Addendum to the Final Environmental Impact Report for the

BP Carson Refinery (Formerly ARCO Los Angeles Refinery) California Air Resources Board (CARB) Phase 3/Methyl Tertiary Butyl Ether (MTBE) Phase-out Project

SCH. No. 2000061074

April 2005

Figure 5-1 Refinery Layout Map (May 2001 Final EIR Figure 2.4-1)

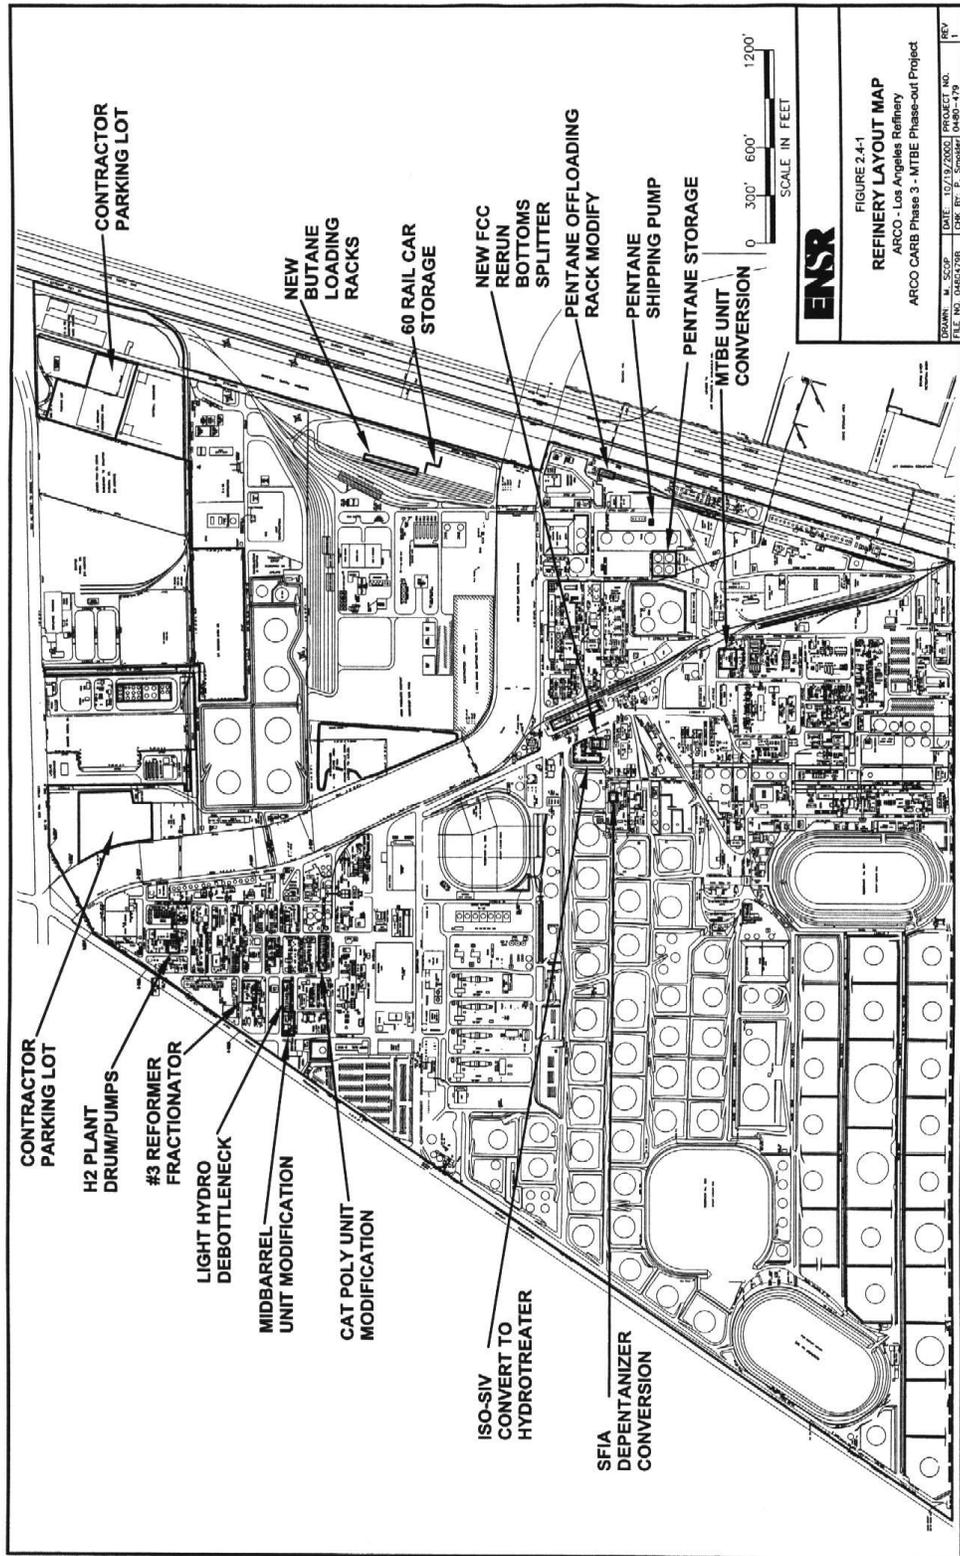
Task No. 7 (conversion of the MTBE Unit to an Iso-octene Unit) in Table 5-1 identifies refinery modifications and new equipment that were evaluated in the May 2001 Final EIR, but that did not occur as scheduled. These modifications did not occur because, as construction of the initial phases of the overall CARB Phase 3 project was underway, additional engineering and process designs specific to the MTBE Unit presented a preferable, but different technology for producing

The currently proposed modifications involve changes to one portion of the CARB Phase 3 project evaluated in the May 2001 Final EIR – the production of iso-octene by converting the existing MTBE Unit that was removed from MTBE service because of the CARB Phase 3 requirement to cease use of MTBE as a gasoline additive. Labeled as “MTBE Unit Conversion” on Figure 5-1 Refinery Layout Map (Figure 2.4-1 in the May 2001 Final EIR), the modified and new equipment associated with the currently proposed modifications would be located within the existing MTBE Unit, as was the case with the MTBE Unit conversion analyzed in the May 2001 Final EIR. The MTBE Unit conversion was not constructed from January to September 2002 as was previously proposed and evaluated in the May 2001 Final EIR. As construction of the initial phases of the overall CARB Phase 3 project was underway, additional engineering and process designs specific to the MTBE Unit presented a preferable, but different technology for producing iso-octene than had been contemplated at the time of the May 2001 Final EIR analyses. This different technology is offered by a different vendor and involves a somewhat different equipment configuration than was previously described in the May 2001 Final EIR.
